SERVICE BULLETIN

AT05-004a

August 1, 2005

2004 – 2005 ARMADA AND TITAN; ATF LEAKING FROM AIR COOLER LINE

Figure 1

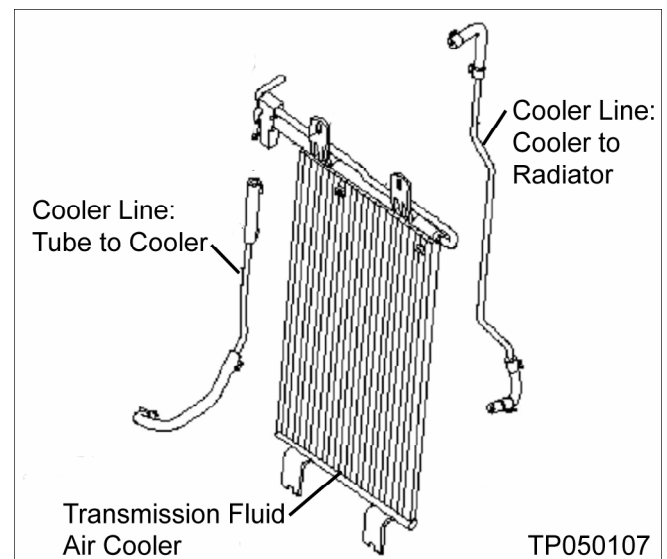
Both early and later type cooler lines are available.

- Early type cooler lines- Make sure to replace the hose clamps that come installed on the cooler line with the new hose clamps listed in the Parts Information. Make sure to follow the instructions under "Additional Procedure Information" on page 3.
- Later type cooler lines-These cooler lines come with the new clamps. Replacement of the clamps is not necessary.

NOTE: New A/T cooler lines include metal tube, rubber hoses, and hose clamps.

Figure 2

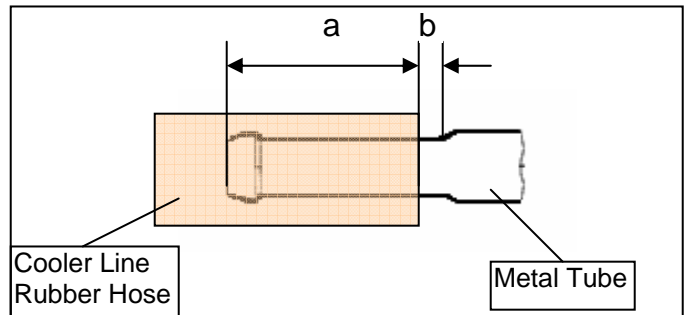
- Install the cooler line rubber hoses on the metal tubes as shown in Figure 2.

a = 30 to 33 mm (1.2 to 1.3 in)

b = 3 to 5 mm (0.1 to 0.2 in)

Figure 3

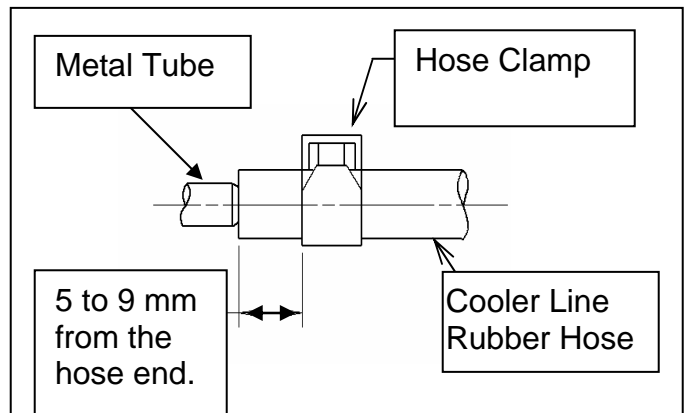
- Position clamps on the rubber hoses as shown in Figure 3.
